**THE NATIONAL GRID COMPANY plc**

**GRID CODE REVIEW PANEL**

**GRID CODE - OC5 CHANGES**

Diagram showing rationalisation of OC5 text to common wording

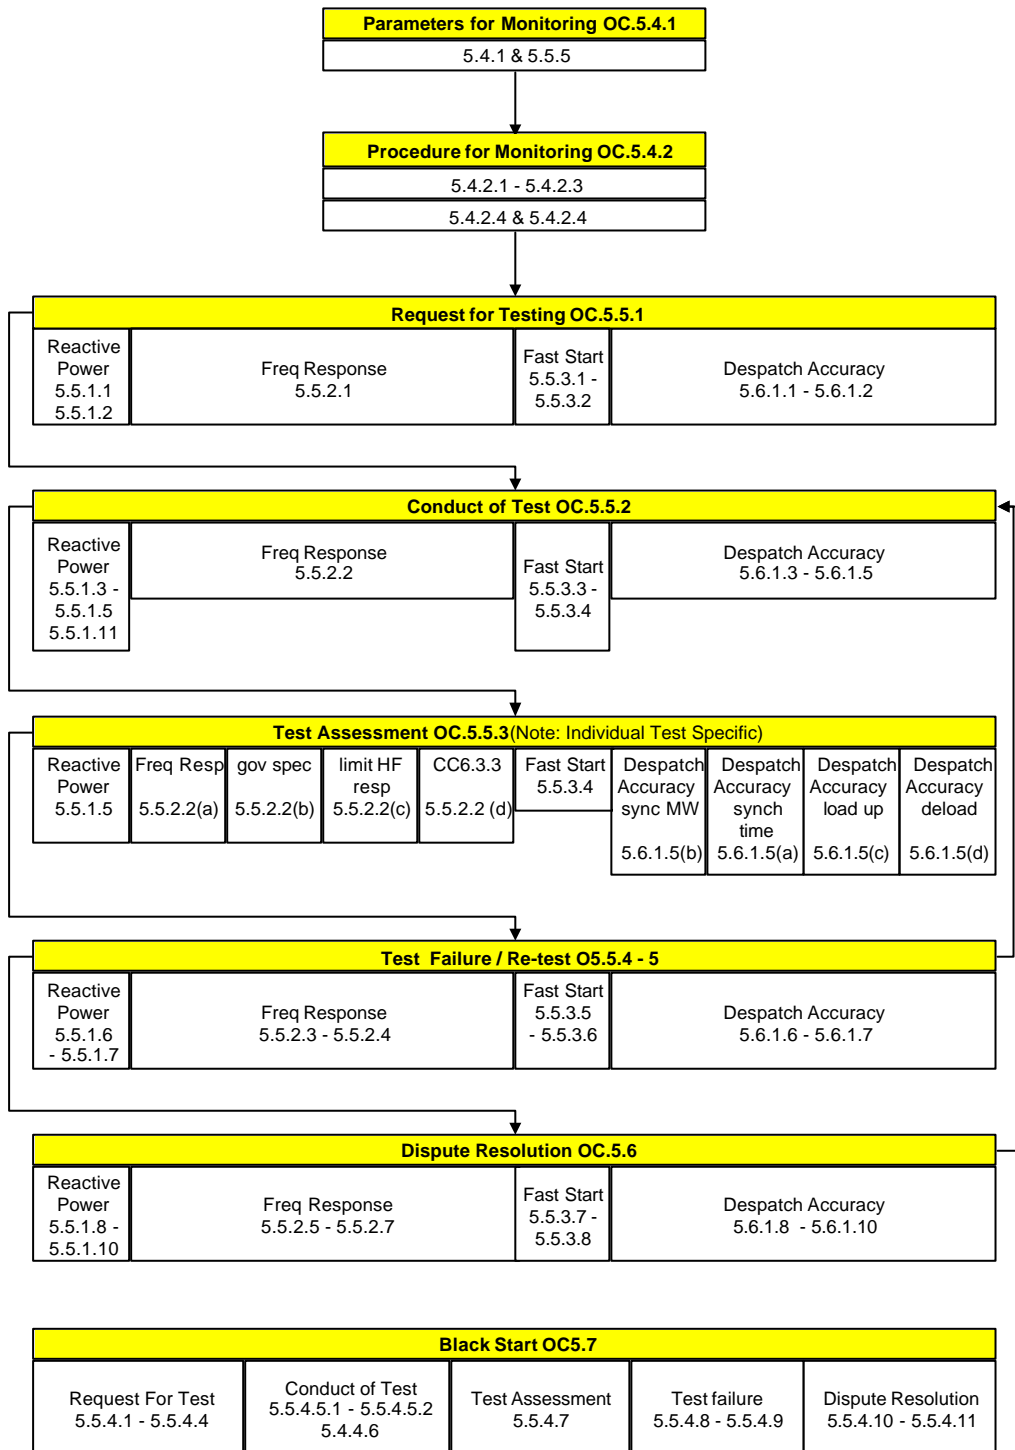
- 3.2. With two exceptions the revised layout for Grid Code section OC5 proposed by the working group rationalises all the procedures for monitoring, testing and disputes resolution into common text. A table has been introduced to set out the assessment criteria applicable to the individual plant performance being measured. The two exceptions referred to above are:-
- a) the requirements for Black Start Testing, which is retained as a separate section (OC5.7), and
  - b) the deletion of OC5.4.2.5 as this level was considered inappropriate.
- 3.3. Attachment 1 to this paper illustrates which sections of text were identified as common, and indicates the proposed structure. Attachment 2 comprises the proposed new wording of OC5, with changes from the existing OC5 shown.
